Report to the Future Melbourne Committee

**Ministerial Planning Referral: TPM-2022-15
1-7 Elizabeth Street and 2-12 Barrett Street, Kensington (Younghusband Stage 3)**

DELEGATE REPORT MINISTERIAL PLANNING REFERRAL

Application no:	TPM-2022-15
DTP application no:	PA2201839
Applicant:	Ivanhoe Cambridge, Irongate and Built c-/ Metropol Planning Solutions
Owner:	Irongate FM No.1 Pty Ltd
Architect:	Woods Bagot
Address:	1-7 Elizabeth Street and 2-12 Barrett Street, Kensington
Proposal:	Buildings and works, use of land for shop, restricted recreation facility (gym), and food and drink premises and a reduction in the standard car parking requirements and car parking consent.
Estimated cost of development:	\$70,000,000
Date received:	13 September 2022
Date amended:	27 June 2023
Responsible officer:	Colin Charman, Principal Urban Planner

Excerpt from Drawing No. TP 3 32511 'Sections 01, 02, 03' of the assessed Architectural Drawings

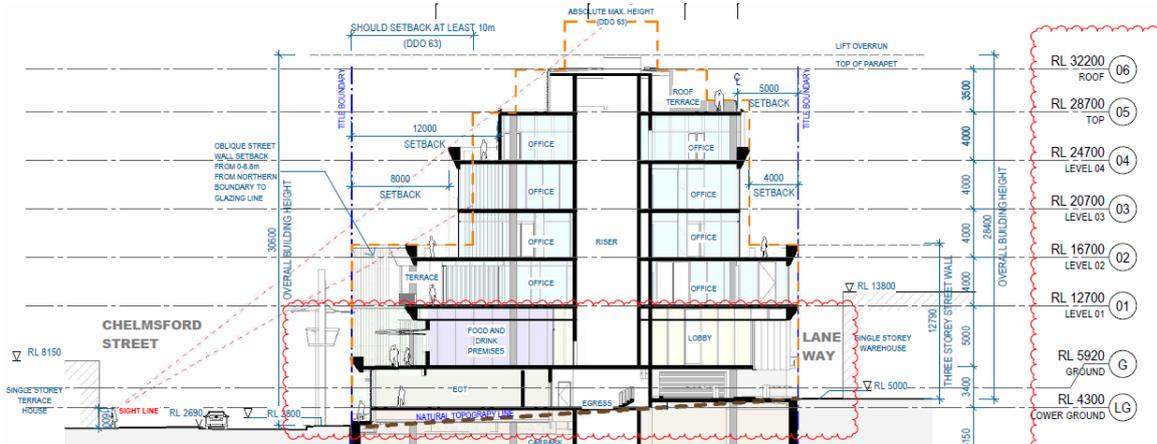
A 2 metre variation from the preferred setback requirement above the Chelmsford Street street wall is considered appropriate, noting the following:

- The development is achieving compliance with the preferred overall height requirement of 6-storeys. Together with level transitions across the site, which contribute to the development presenting as a 5-storey building to Elizabeth Street to the north of the site, achieving the preferred height requirement will reduce the impression of bulk and scale presented by the development to Chelmsford Street.
- The building includes progressive setbacks, with taller form above Levels 2 and 3 being setback 12 metres from the title boundary.

Excerpt from Drawing No. TP 3 32511 'Sections 01, 02, 03' of the assessed Architectural Drawings

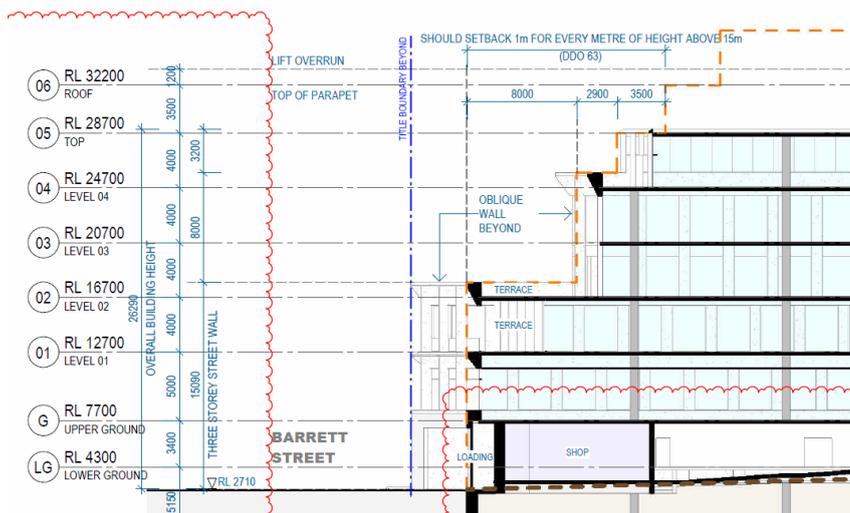
- Above the Barrett Street street wall, the development is setback 8 metres, with progressive setbacks demonstrating compliance with the requirement of DDO63 (Area 4) that buildings be set back 1 metre for every metre of height above 15 metres.

- Above the Corporation Lane 0177 street wall, the development is setback 4 metres, complying with the requirement of DDO63 (Area 4) (see above Figure).

Excerpt from Drawing No. TP 3 32511 'Sections 01, 02, 03' of the assessed Architectural Drawings

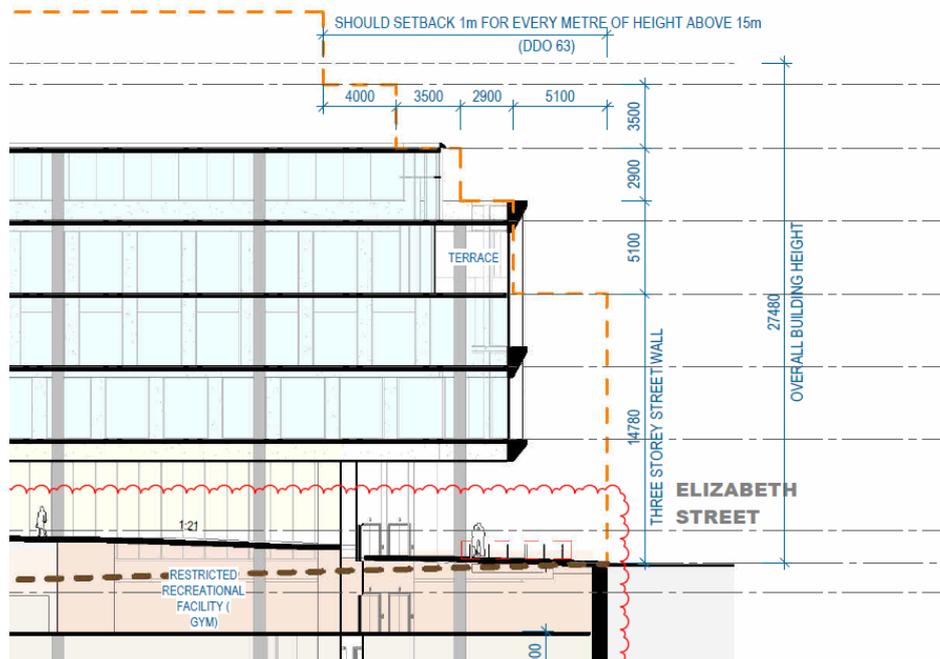
- While not providing a street wall to Elizabeth Street, the proposed development demonstrates compliance with a recession plane created by the upper level setback requirements of DDO63 (Area 4) applying to this street.
